**SECTION 4.55(2) MODIFICATION AND STATE
SIGNIFICANT DEVELOPMENT ASSESSMENT REPORT:**

***Tourist and Visitor Accommodation at the Sandstone
Precinct (Lands Building and Education Building and
surrounding road and public reserves), 23-33 and 35-39
Bridge Street, Sydney***

SSD 6751 MOD 2 and SSD 7484

Environmental Assessment Report
Sections 4.55(2) and 4.40 of the *Environmental Planning
and Assessment Act 1979*

Figure 8: Comparison of the approved (red) and proposed (blue) height of the Education Building envelope height (Bent Street elevation) (Base source: Applicant's RtS)

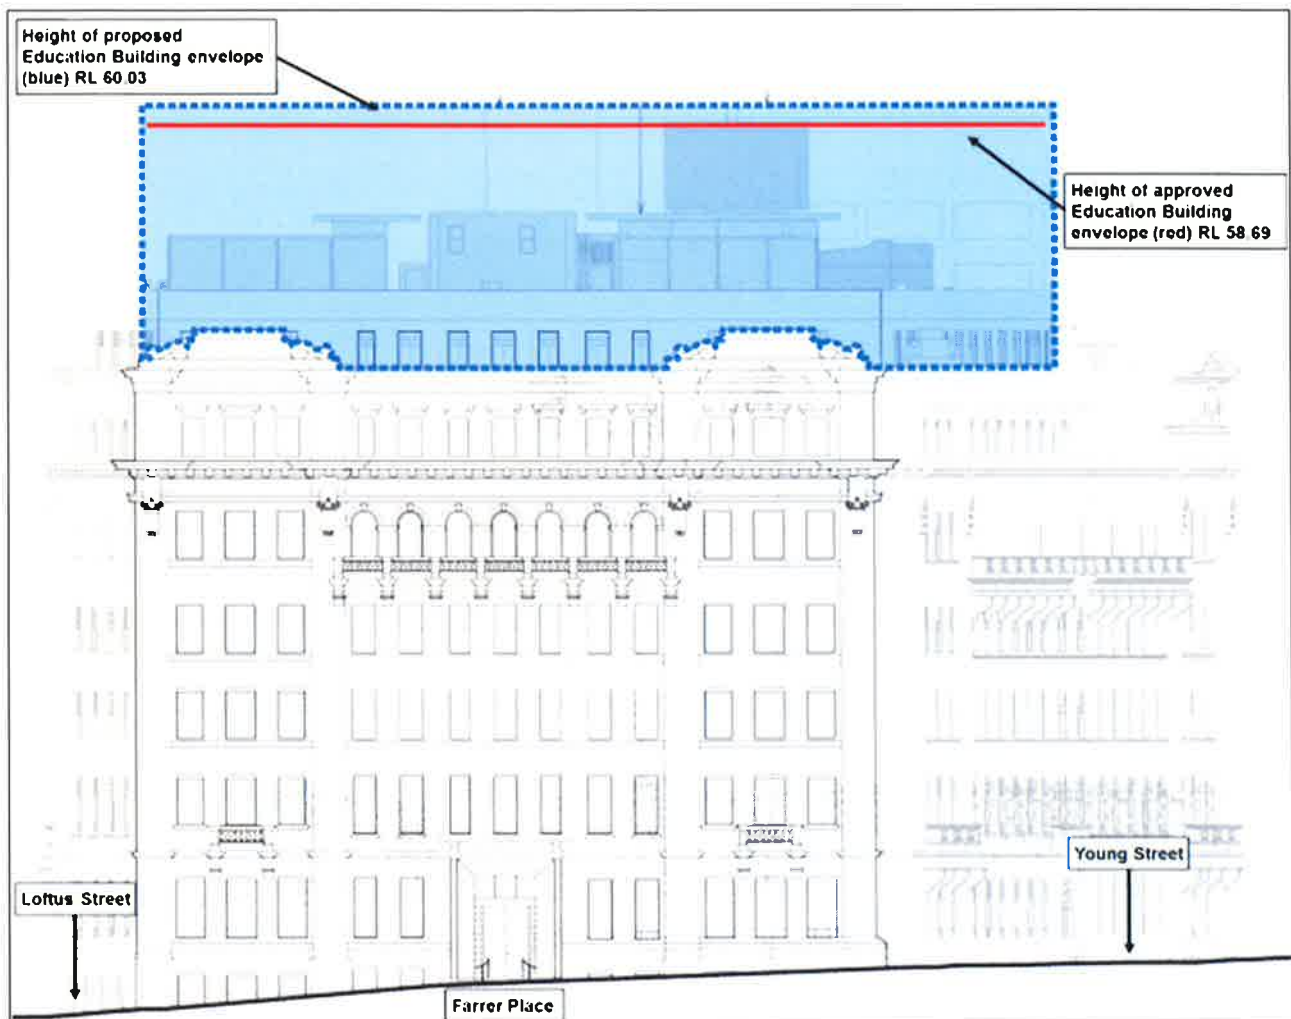
Public submissions raise concern that the increased height of the Education Building envelope would be overly dominant and adversely impact on views. In addition, the submissions raise concern the changes to the Lands Building roof would adversely impact on the heritage significance of that building.

The Heritage Council NSW supports the roof top additions stating the proposal would improve the heritage outcomes for both buildings. Council did not object to the modifications subject to the inclusion of conditions requiring no additional roof plant or ductwork to extend beyond the building envelope.

The GA NSW have reviewed the modified envelopes and works proposed within them and advise the forms proposed for the additions to the heritage buildings are contemporary, respectful and appropriate and with further detailed development has the potential to evolve to be a positive element for these important buildings.

Figure 8: Lands Building envelope height (right) and location (left) (Base source: Applicant's RtS)

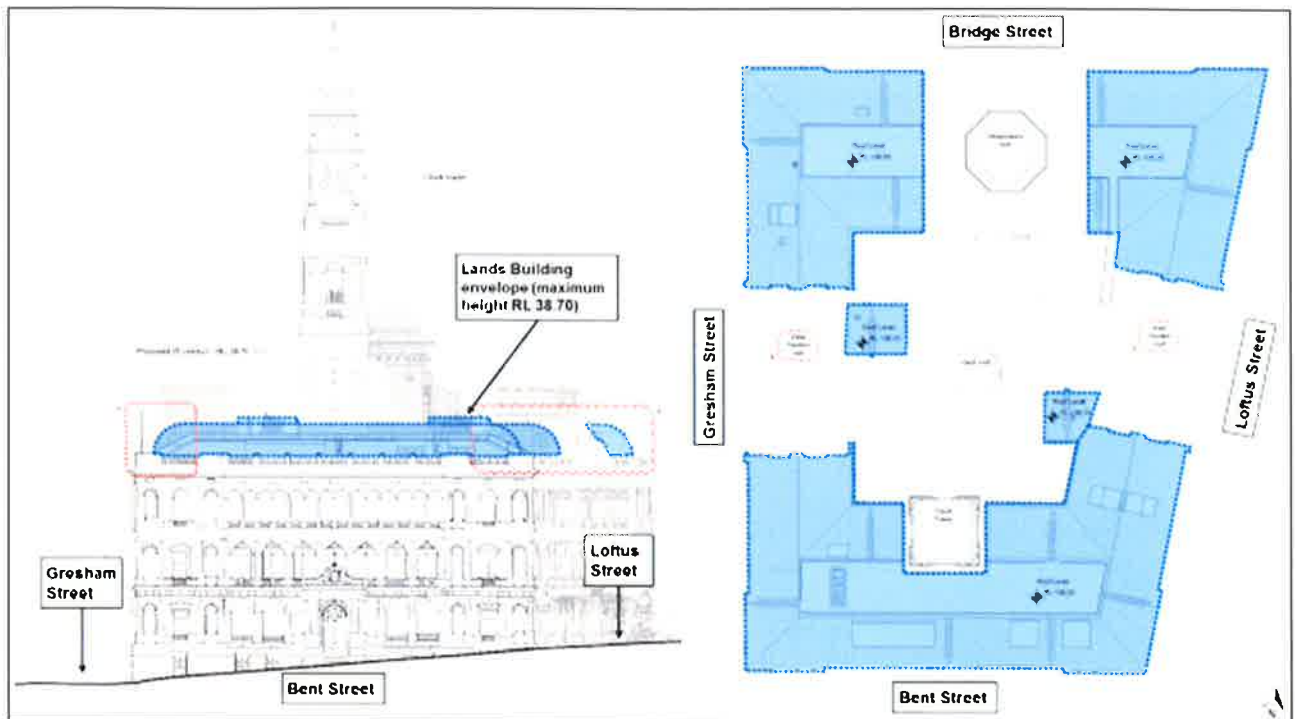
The Applicant has provided a Statement of Heritage Impact (SHI) and View Impact Statement (VIA), which considers the impacts of the proposed envelopes and conclude the:

Figure 11: Comparison of the stage 1 concept approval and modified Education Building envelope, including the concurrent stage 2 SSD development (Base source: Applicant's RtS)

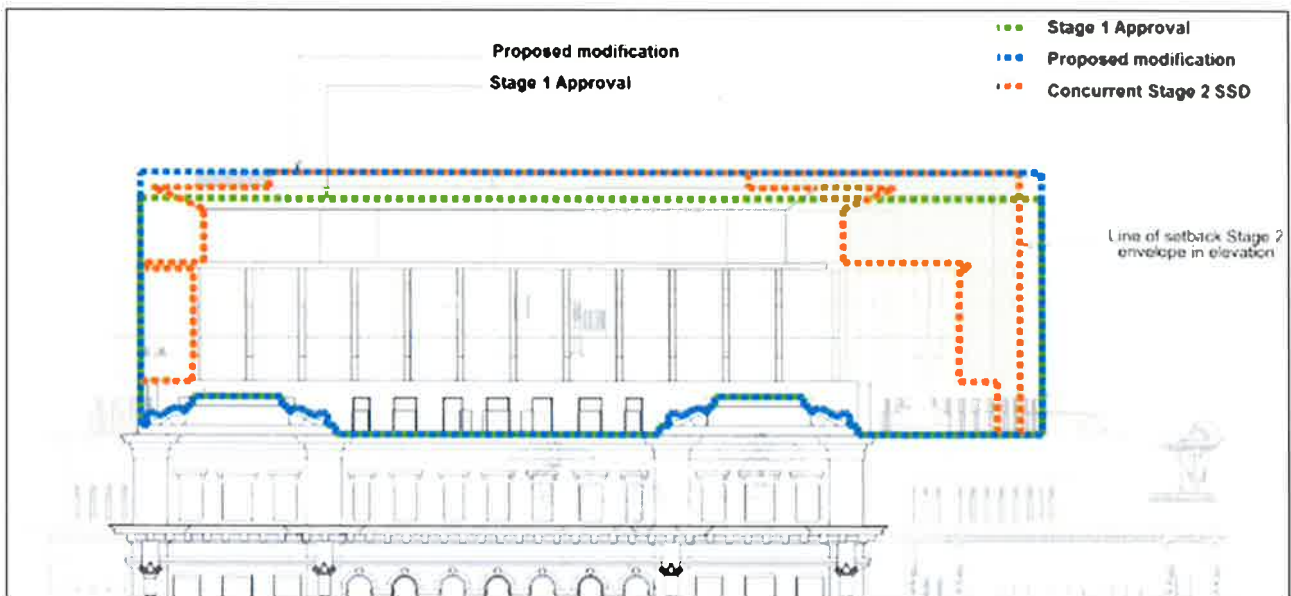
- the increase in height is minor and would be indiscernible when viewed from the surrounding open spaces, streets and public domain (**Figures 10 and 11**)
- the revised building envelope would not extend higher than the tallest part of the existing building
- the revised building envelope ensures a future building is capable of achieving appropriate internal amenity

Figure 15: The proposed layout of the level 7 and 9 roof additions to the Education Building, with setbacks (shown in red) and a comparison against the stage 1 concept approval envelope (shown in blue) (Base source: Applicant's EIS)

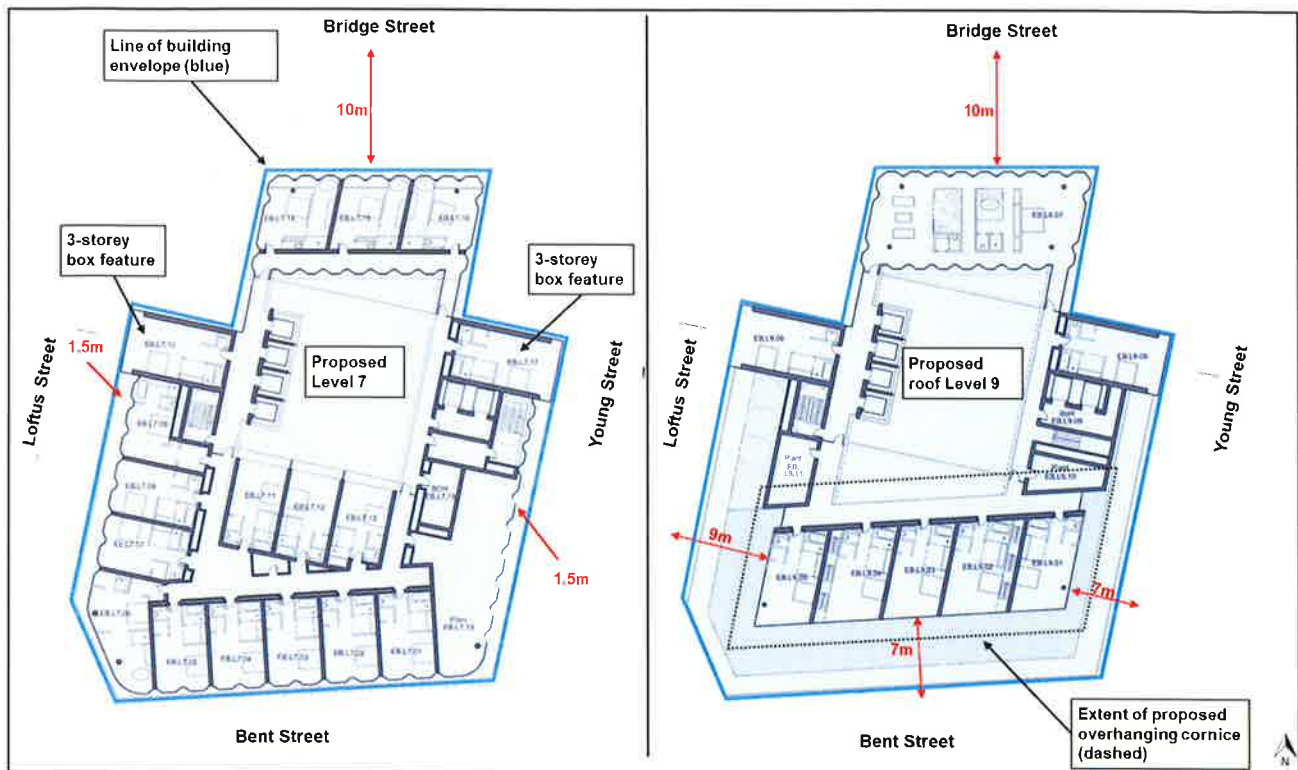
Concern was raised in public submissions about the visual dominance of the proposed Education Building roof extension and its impact on the character of the building. Council supports the provision of curved glass bays at levels 7 and 8 and recommended a condition to ensure the curved glass bays are not modified as part of the design development of the building to a faceted form, and prototypes be constructed prior to the issue of the relevant Construction Certificate. The Heritage Council requested further justification for the provision of water-villas at Level 9 of the Education Building.

The GA NSW recommended the composition of the extension design should be developed and improved, which the Department considers can be achieved through design development under the oversight of the DRP.

Figure 17: Proposed layout of the Lands Building roof extension, with stage 1 modification envelope highlight blue (left) and proposed grid-shell roof (right) (Base source: Applicant's EIS)

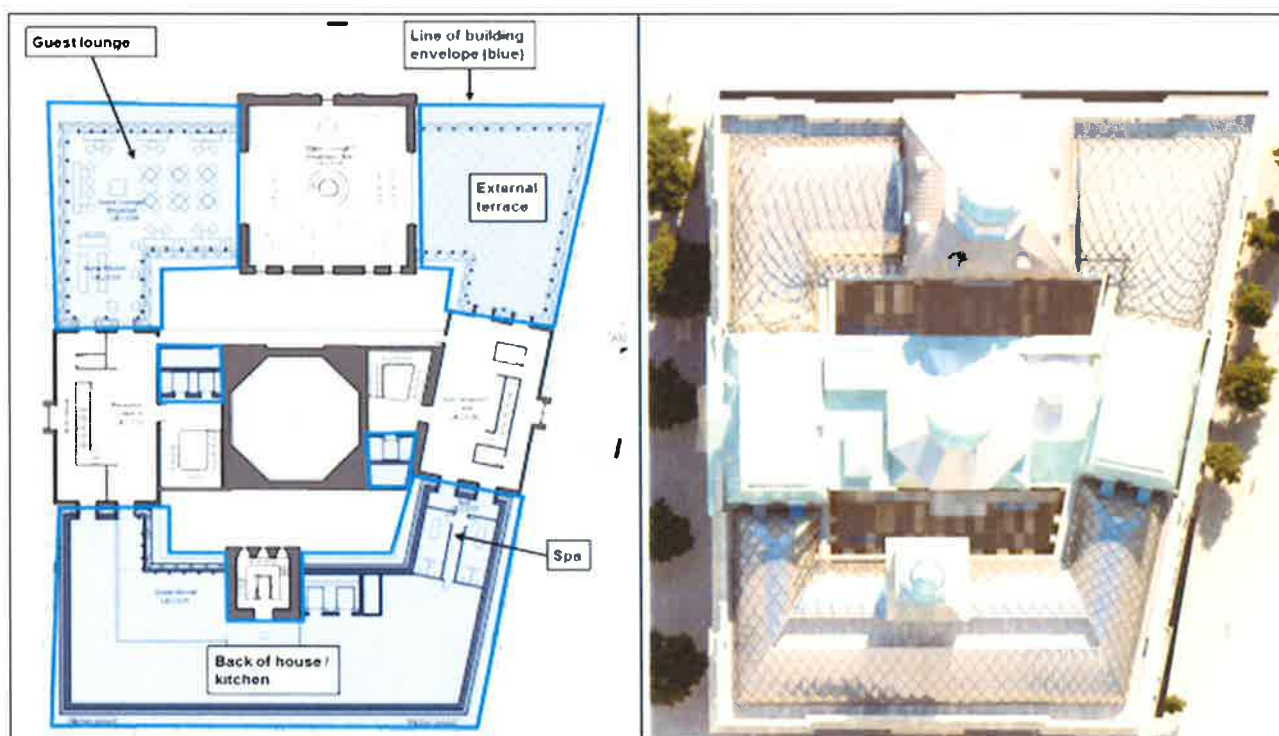
The Department notes the concerns raised in public submissions about the heritage impacts of the proposed roof addition. The Department however notes the existing profiled metal roof (and associated structures) is a modern (20th century) construction and does not contribute positively to the overall appearance of the building or its heritage significance (**Figure 13**). The Department therefore supports the principle of its removal and replacement with a new roof. In addition, all major roof features, which are of exceptional heritage significance, are retained and will not be affected by the proposed roof.

- is contained wholly within the building envelope (as supported in **Section 5.2.2**)
- is single storey and set behind the existing sandstone parapets, and would therefore not visually dominate the major roof features, which have exceptional heritage significance (**Figure 18**)
- is a lightweight modern and visually interesting and appealing addition, that contrasts with the grand proportions, robust architecture and heavy sandstone construction of the Lands Building
- would not be visible from immediate surrounding streets and is acceptable in more distant views
- provides access to the roof level of the Lands Building, which will provide for a new viewing perspective to appreciate the major roof features of exceptional heritage significance.
